Plan Commission

Special Meeting

Agenda

Monday, April 3, 2017	7:00 PM	De Pere City Hall Council Chambers
------------------------------	----------------	---

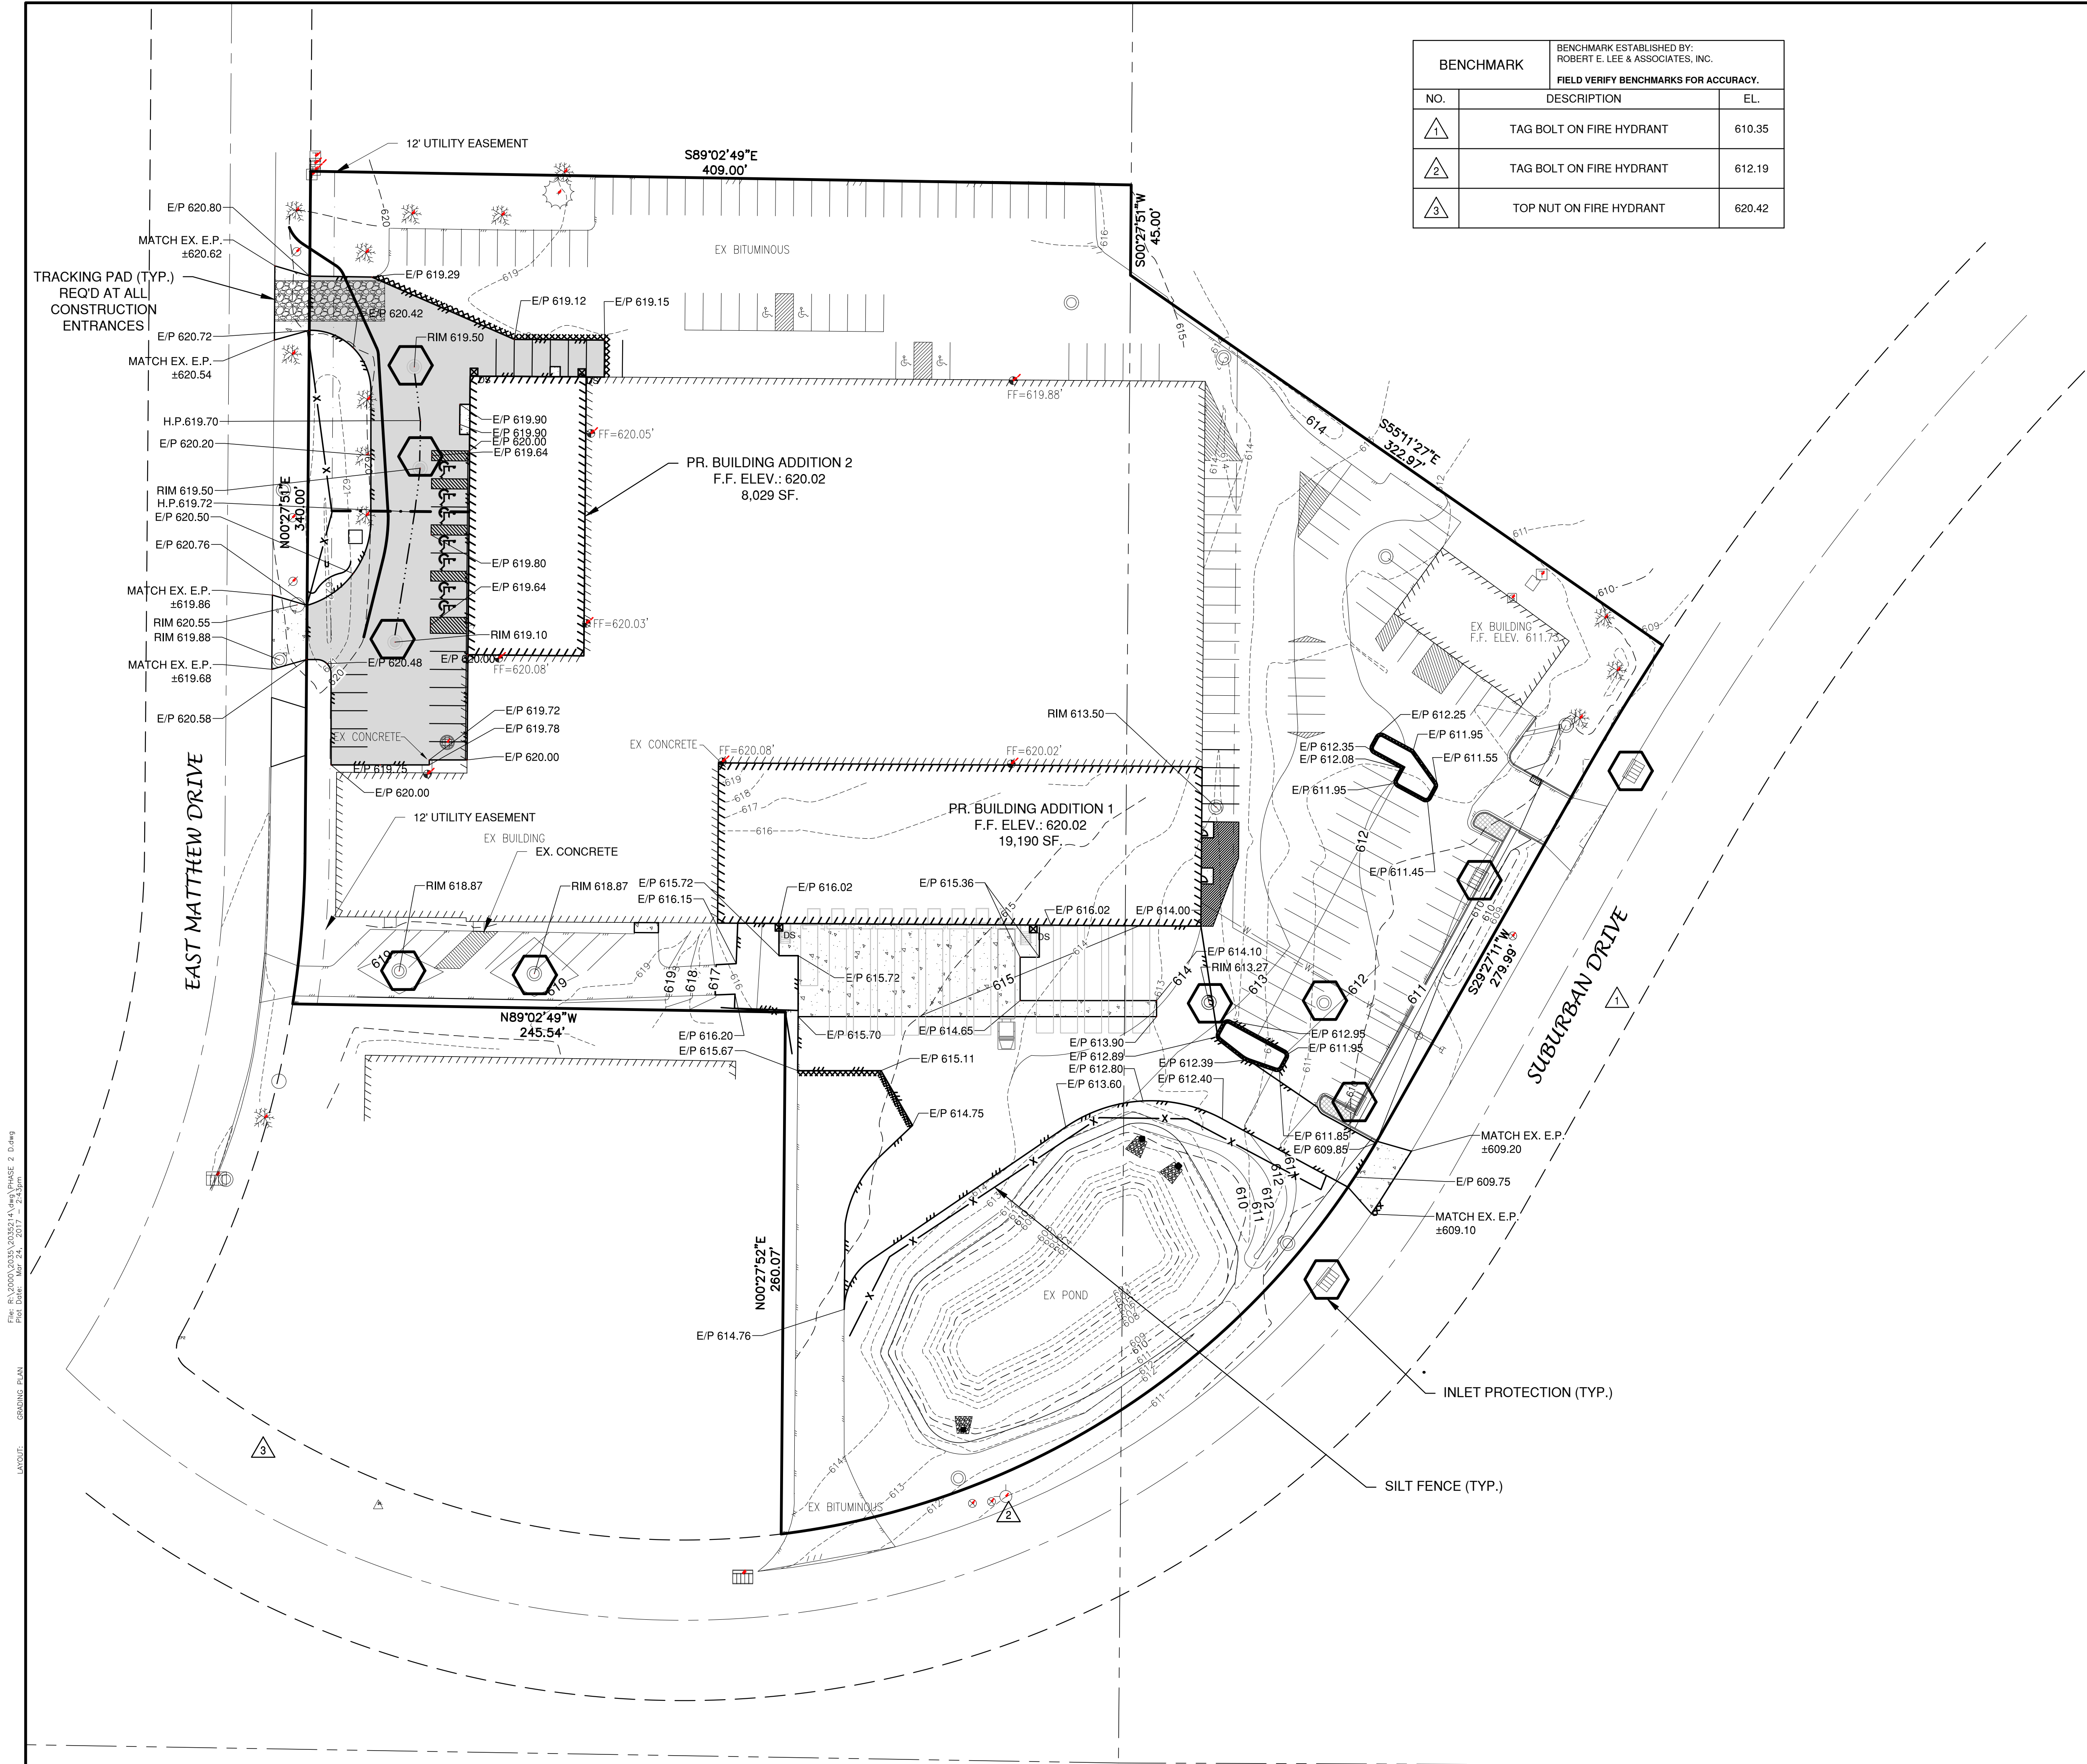
1. Provide a map of the critical route for flow off the site during construction to correspond with the WDNR Soil Loss & Sediment Discharge Calculation Tool.
2. A maintenance agreement will be required for the final storm water management facility. This will be provided by the City. After signed by the owner, the City will record.
3. The parking at proposed building addition #2 and the loading docks at proposed building addition #1 contradict previous site plans. Furthermore, the parking layouts previously mentioned are different on page 3 from the remainder of the plans.
4. Loading docks shown on page 3 conflict with traffic flow for one way entrance off of East Matthew Drive.
